Southend Victoria Gateway Post-Implementation Design Review

Report, September 2013

Diagram 1

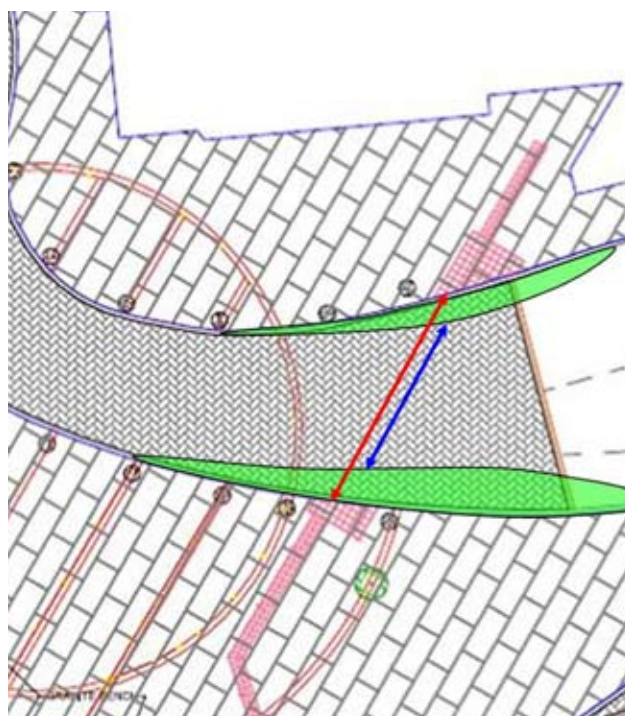
An additional way of addressing concerns over potential pedestrian/vehicle conflict would be to reduce the width of the vehicle path at the point where most of the pedestrians cross on the route between the southern station entrance and the

town centre. The vehicle path here flares to allow access to/egress from the bus stops to the east; and, because the pedestrian desire line is on the diagonal, the walking distance across the vehicle path is lengthened further (see photo).

While there is theoretical scope for narrowing the vehicle path at this point, as indicated in Diagram 1, this would be likely in practice to have a negative impact on bus queuing in a connection with movements into and out of the bus stops.

Since this could have negative knock-on effects both on bus passenger journey times and on local pedestrian amenity, and would also be costly, the option of narrowing the vehicle path should only be considered if clear evidence of overall benefit is presented. Notwithstanding anecdotal concerns expressed in the early days after scheme opening, there is currently no compelling evidence that the scheme requires modification in this regard.

Diagram 3

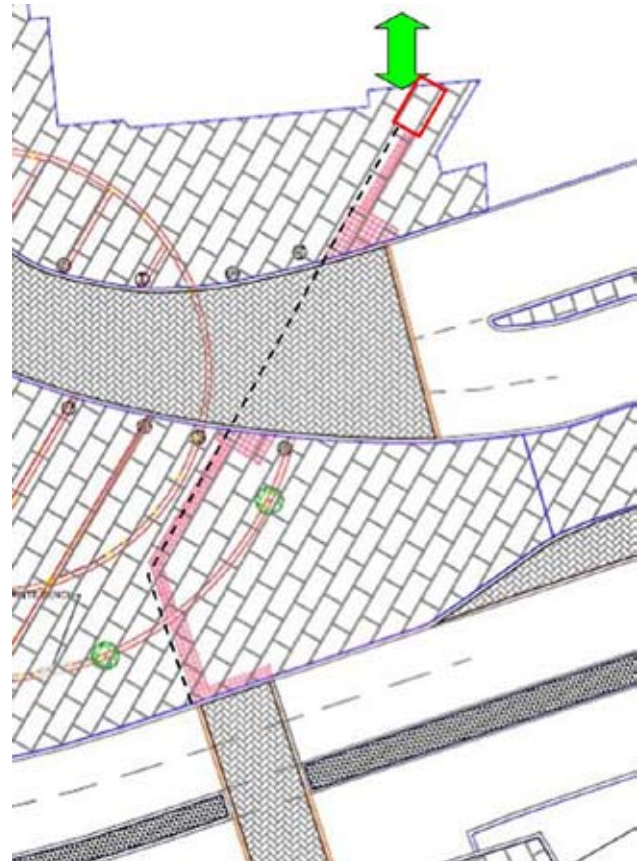
While the above are presented as options for consideration, one change that is required concerns the guidance path tactile paving designed to provide a link across the main space from the station southern entrance to the crossing of Queensway. This is currently incomplete, stopping short of the station entrance and with the gap only partially filled by temporary by stick-down rubber corduroy (see red box in Diagram 3 and picture on page 16). This temporary arrangement should be made permanent as soon as possible, using granite elements as for the rest of the guidance path track.

- a) Install corduroy tactile paving to mark the full edge of the main vehicle/bus path where this is flush (and there is no existing blister paving). Consider use of appropriate colour contrast (e.g. dark grey) and consider removal of ‘cannon ball’ bollards, other than where necessary to prevent damage caused by overrunning vehicles.
- b) Extend ‘guidance path’ tactile paving all the way to the southern station wall, replacing temporary rubber corduroy extension.

Diagram 4

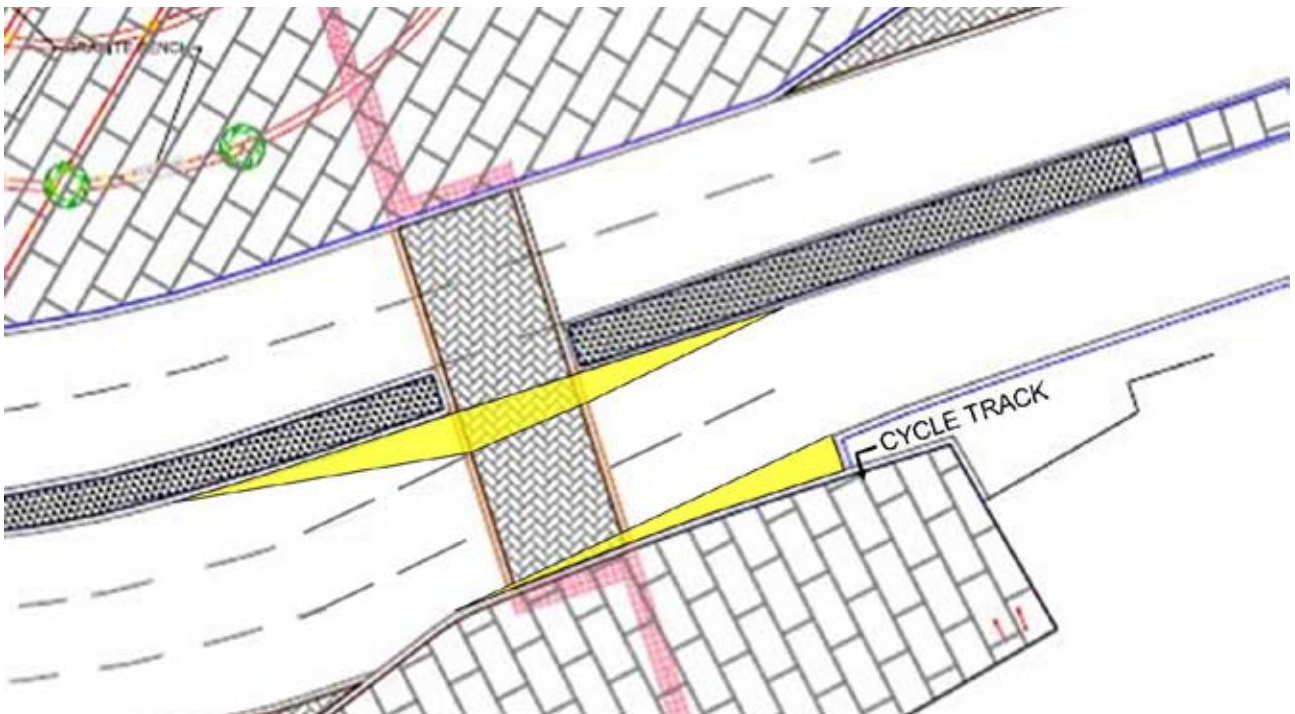
The main concern here relates to pedestrian crossing activity at the formal Toucan facility, principally pedestrian over-crowding the central reservation and also walking in between static vehicles at times when vehicles have a green light. Replacing the Toucan with a Zebra crossing was suggested by some review participants, but this would be likely to have adverse impacts on the efficiency/queuing of vehicles at peak times, which would quite likely feed back into adverse impacts on pedestrians related to pedestrian visibility and driver frustration.

This physical change is made relatively straightforward by the fact that there is currently an unusable half lane-width on the westbound Queensway carriageway just west of where the separated cycle track terminates and feeds cyclists into the shared southern hard-paved space. The essentials of the proposed change are shown in Diagram 4, with the new pedestrian area shaded yellow. SBC officers consider that this proposed arrangement would also assist with improved lane discipline by drivers, and hence may also help to ease congestion and improve road safety.

- c) Widen the central pedestrian reservation by local carriageway realignment and reducing the westbound carriageway to just two lanes of equal width at that point.

Diagram 5

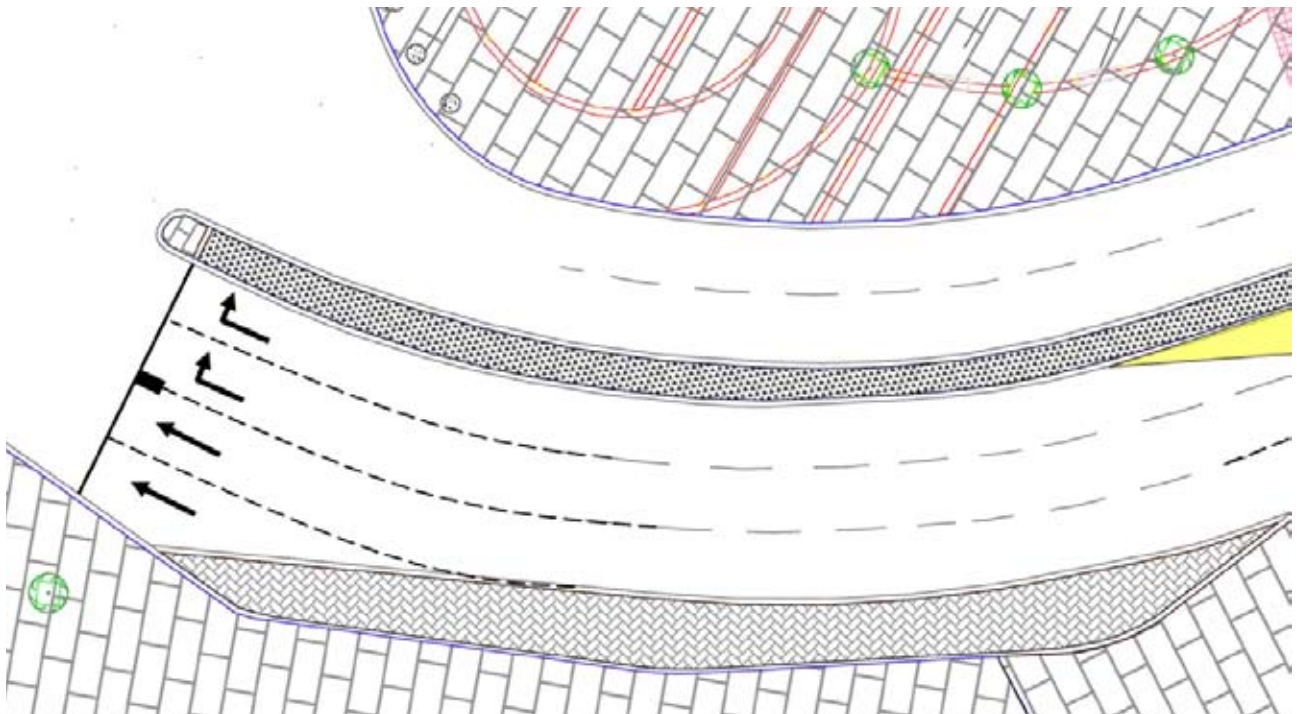
The short nearside filter lane into a four-lane-wide ASZ is of extremely limited (if any) practical value to cyclists, and may even encourage cyclists to undertake hazardous manoeuvres. They also represent an inefficient use of the carriageway

Using the space currently occupied by the cycle filter lane, as well as the existing 'wasted' space between it and the bus stop bay, it would be possible to reconfigure the layout and modify the signal infrastructure and controls so as to allow the ahead and right-turn movements to be separately signalled and the whole junction to run more efficiently as a result.

The effects of this proposal will need to be modelled to help clarify precisely which new layout will be most beneficial in terms of general junction efficiency, bus priority and also pedestrian and cyclist safety and convenience (at the controlled crossing points). One possible revised layout is shown in Diagram 5.

- d) Remove marked cycle feeder lane and advanced cycle stop zone; and
- e) reconfigure lane markings/layout and signal controls to increase efficiency and safety for all users, including cyclists and pedestrians.
